Access Compliance Report Public Rights-of-Way (Curb Ramps)

Main Street: MAIN_ST Cross Street: THIRD_RD Location: E

ADA ID: RPRK211029125555 Ramp Type: Type 4 - Parallel Initial Pass/Fail: Fail Overall Compliance: No Severity Score: 2

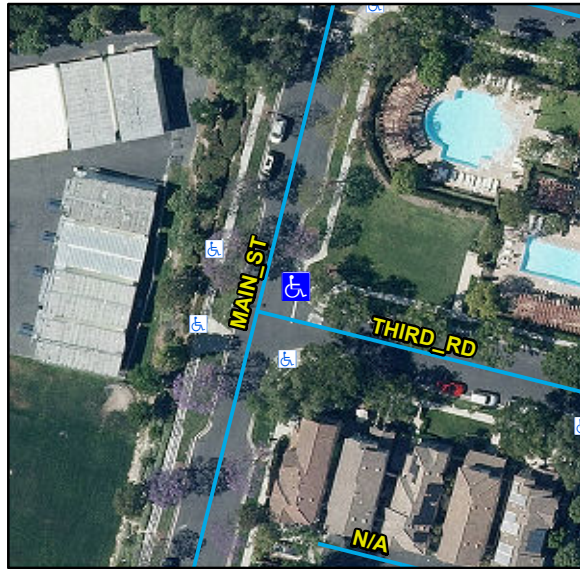
R204.3, R304.5.3, STD 1115

Compliance	Description	Data	Compliance	Description	Data
N/A	Ramp Length LT (in)	105	N/A	Ramp Length RT (in)	110
Yes	Ramp Width LT (in)	90	Yes	Ramp Width RT (in)	90
Yes	Ramp Run Slope LT (%)	6	Yes	Ramp Run Slope RT (%)	3.1
No	Ramp Cross Slope LT (%)	3.9	No	Ramp Cross Slope RT (%)	3.4
N/A	Landing Present	N/A	N/A	DWS Provided	N/A
N/A	Landing Length (in)	N/A	N/A	DWS Contrast	N/A
N/A	Landing Width (in)	N/A	N/A	DWS Length (in)	N/A
N/A	Landing Run Slope (%)	N/A	N/A	DWS Full Width	N/A
N/A	Landing Cross Slope (%)	N/A		DWS Offset Type	N/A
N/A	Landing Movement Obstructed?	N/A	N/A	DWS Offset Left (in)	N/A
	Landing Movement Type	N/A	N/A	DWS Offset Right (in)	N/A
N/A	Landing Shared	N/A			
N/A	Clear Space	Yes			
N/A	Clear Space To Crosswalk (in)	N/A			
N/A	Marked Crosswalk 1	No	N/A	Marked Crosswalk 2	No
	Crossing 1 Direction	NW		Crossing 2 Direction	SW
	Marked Crosswalk 1 Width (in)	N/A		Marked Crosswalk 2 Width (in)	N/A

Remove & Replace Curb Ramp With Two New Directional Ramps or Equivalent.
